General File ID or BMP ID: CC002

**Stormwater Management/BMP
Record Drawing and Construction Certification Review
Tracking Form**

Record Drawing / Construction Certification Submittal for a BMP

**McLaws Centre
 BMP RECORD DRAWING PLAN
 SEDIMENT FOREBAY**
 County Plan Number SP-119-01 - BMP ID Code: CC 002
 James City County Virginia

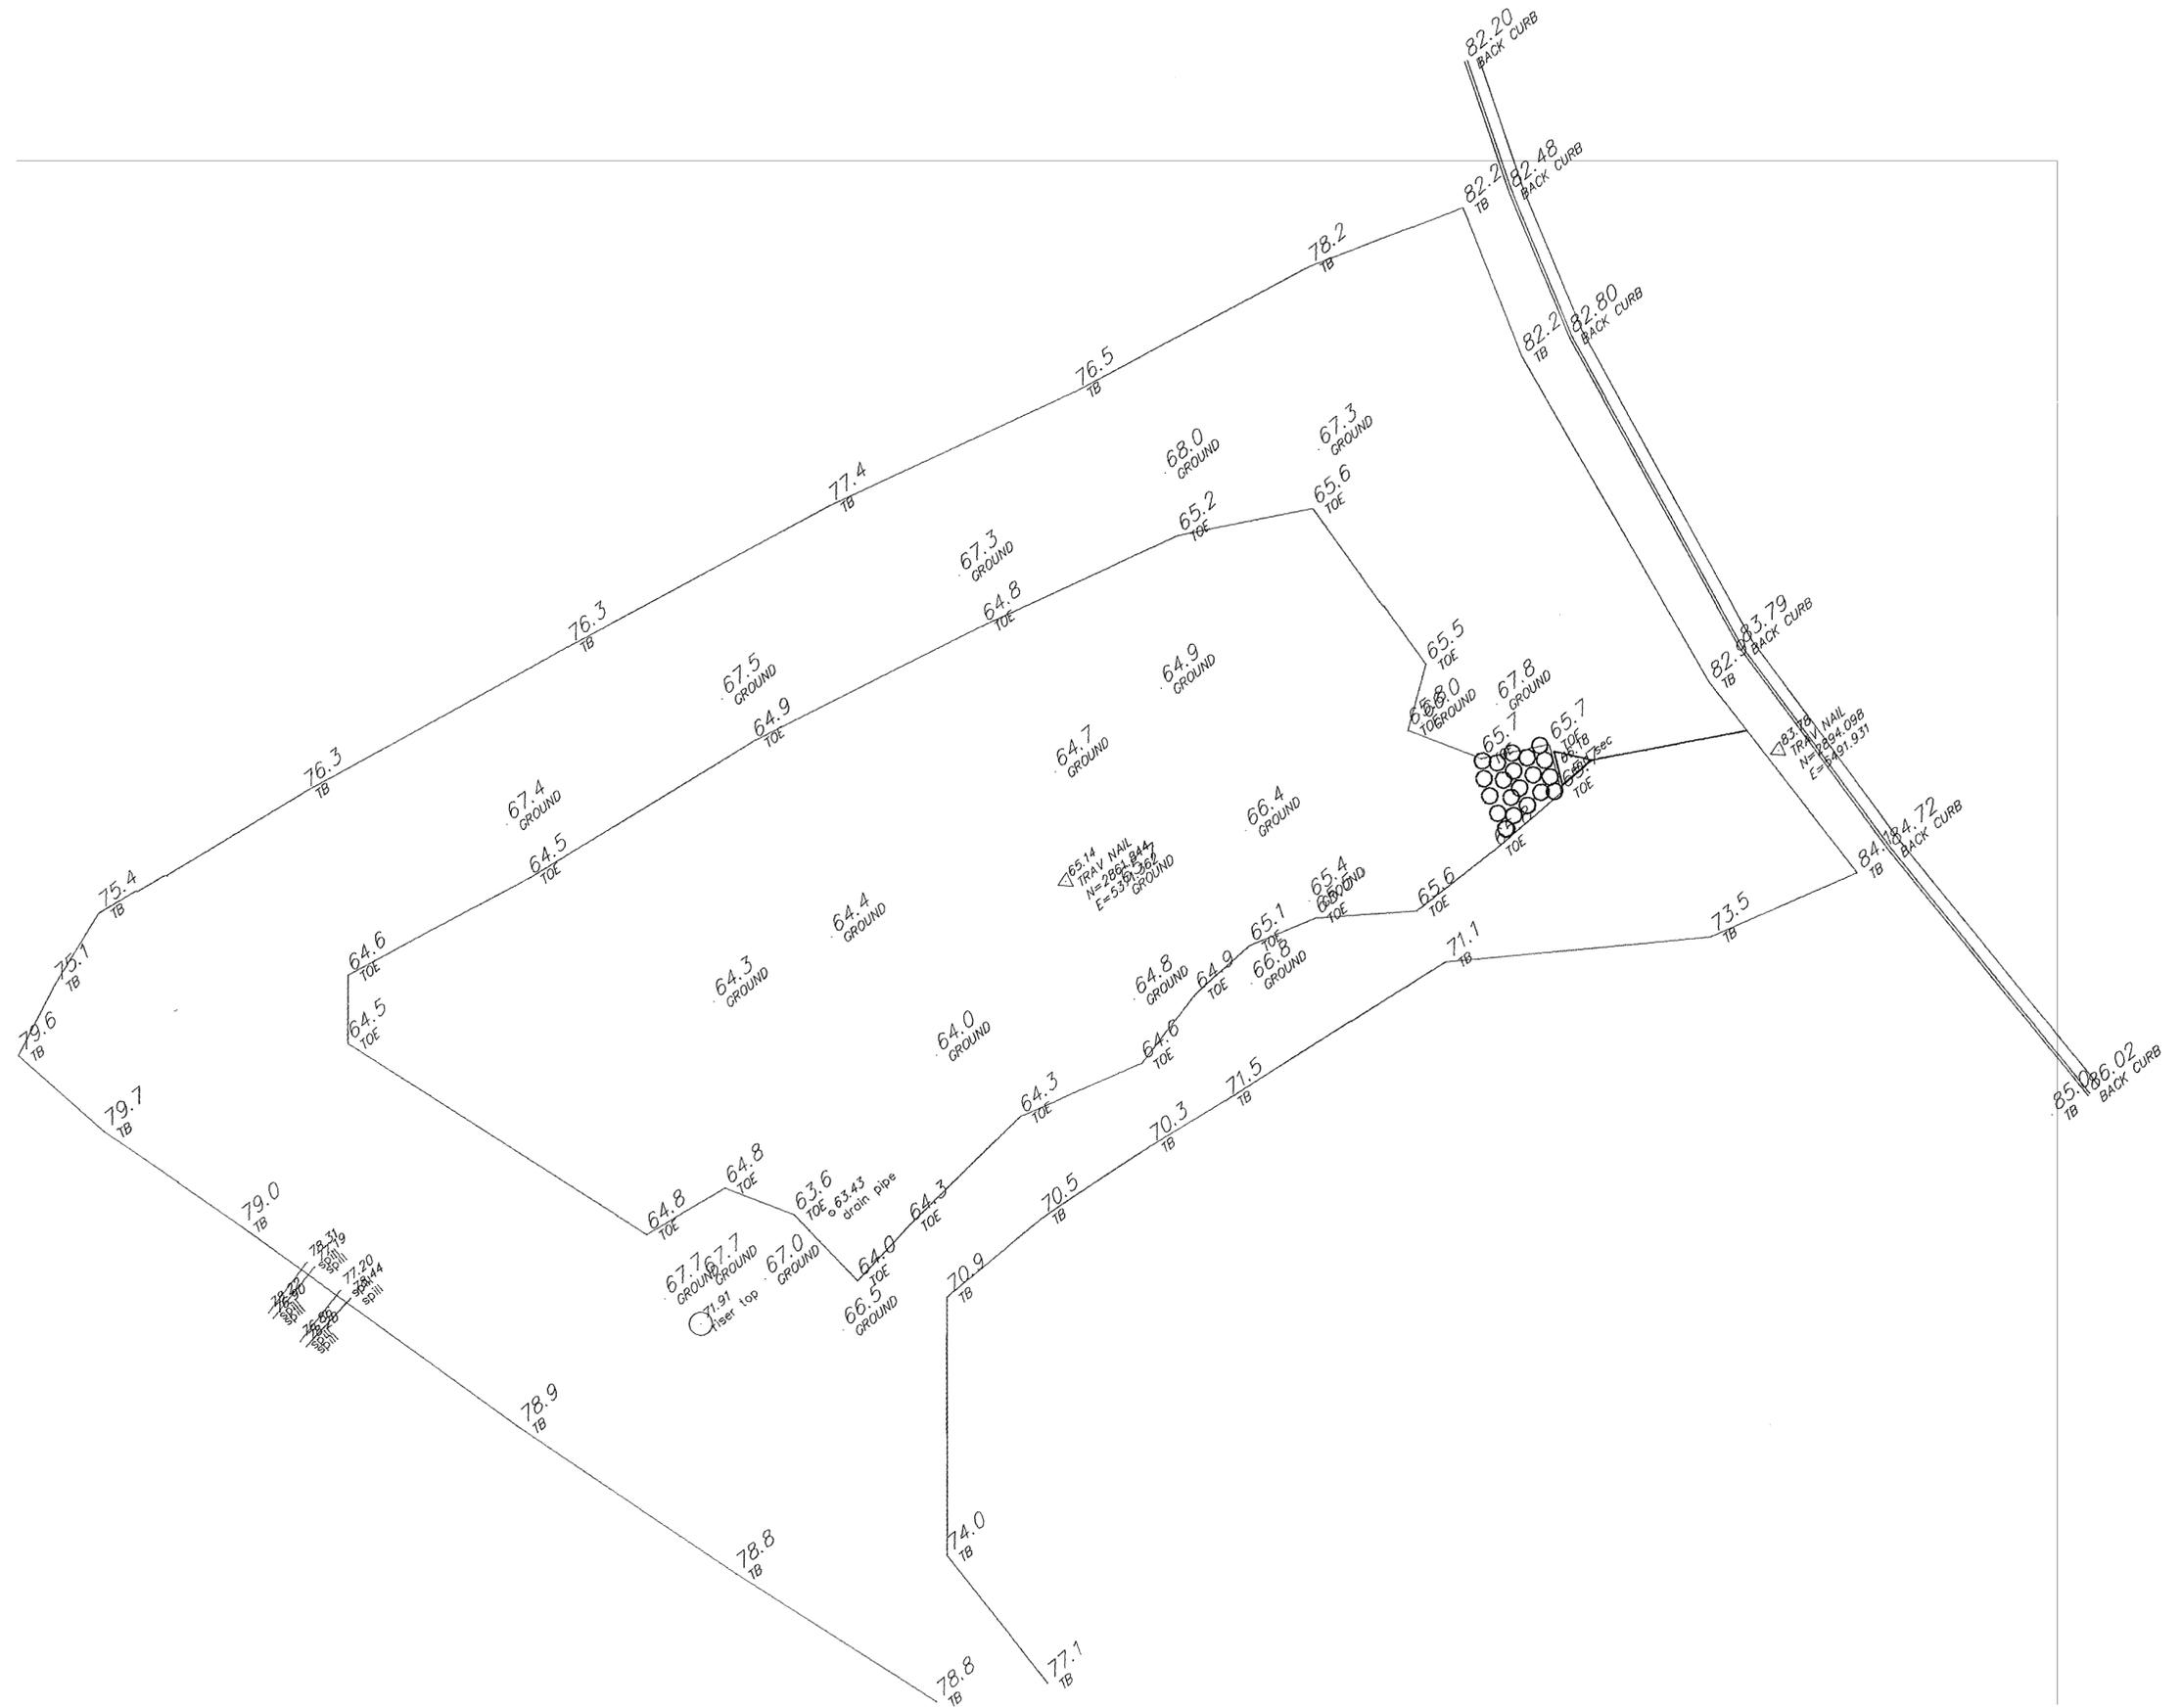
*NEED CC? (No)
ASBUT (GERT)*

Show CRIPST ELEV 71.91? Label CAP (As this was part of plan.)
